Title of Change:	To add 39 OPNs for Packing quantity increase from 450ea/box to 1350ea/box that included pin dimension and color change for TO247&TT3PN for Automotive products
Effective date:	08 Feb 2022
Contact information:	Contact your local onsemi Sales Office or Daisy.Zhi@onsemi.com
Type of notification:	This Product Bulletin is for notification purposes only. onsemi will proceed with implementation of this change upon publication of this Product Bulletin.
Change Category:	Test Change
Change Sub-Category(s):	Shipping/Packaging/Marking

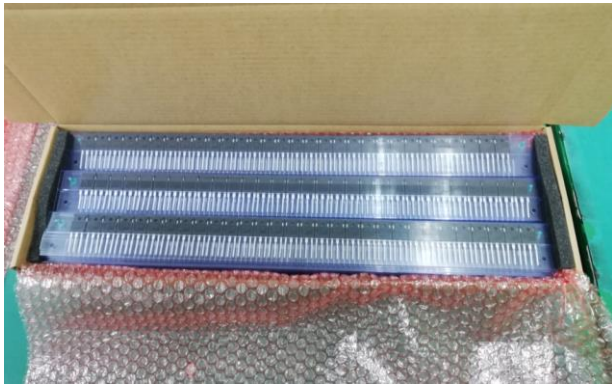
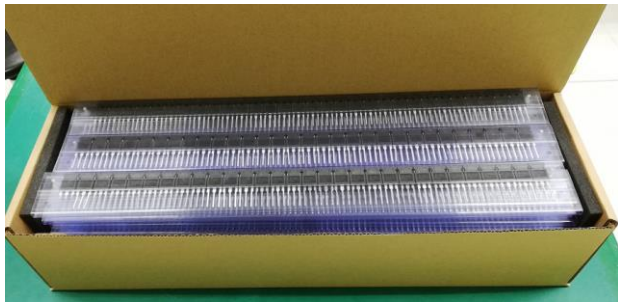
TT3P/ TO247	Quantity per box	
	Current	Proposed
MPQ	450 units	1350 units(remove the bubble bag fill)
Entity Photos		
Stack Floors	5	15
